Appl. No. 09/802,289 Amdt. dated July 21, 2004 Reply to Office Action of April 27, 2004 **PATENT**

# REMARKS/ARGUMENTS

Applicant: Ashley Saulsbury et al.
LIW COMPUTER PROCESSING ARCHITECTURF
SCALABLE NUMBER OF REGISTER FILES Sheet 3 of 5

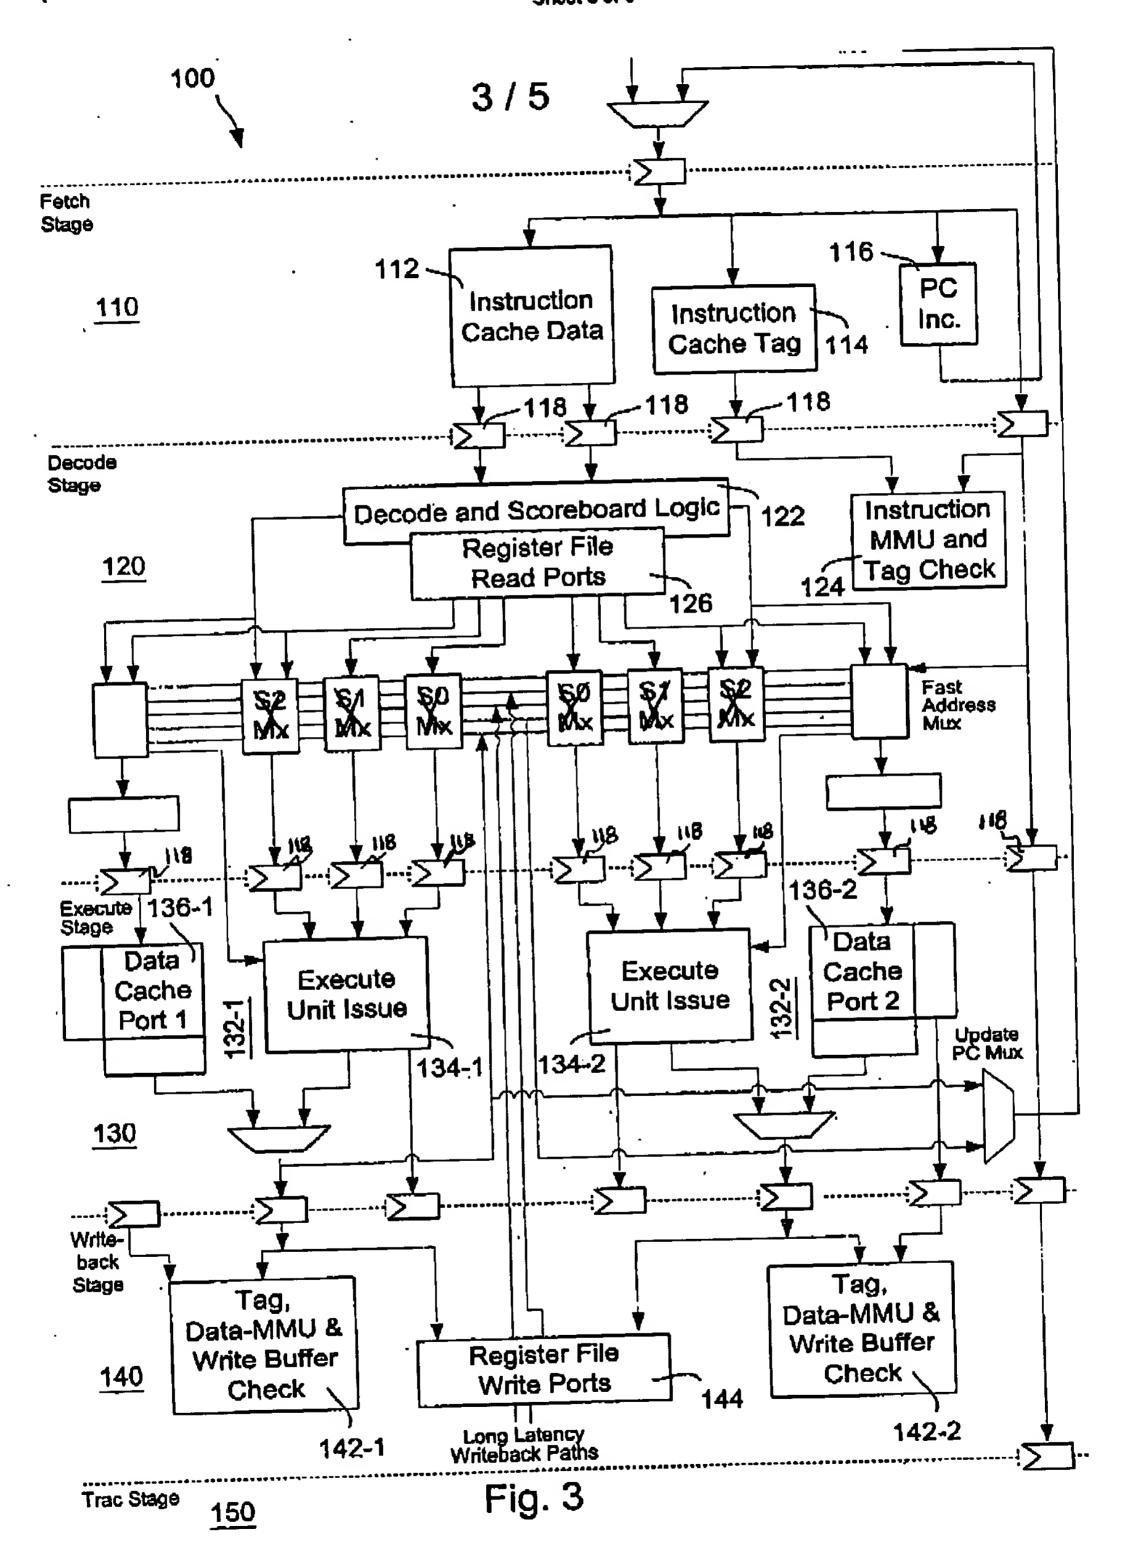
To address paragraphs 4-6 of the Office Action, amendments to the drawings are proposed. Specifically, FIGs. 3 and 5 are amended. Should these changes be found acceptable, amended formal drawings will be prepared.
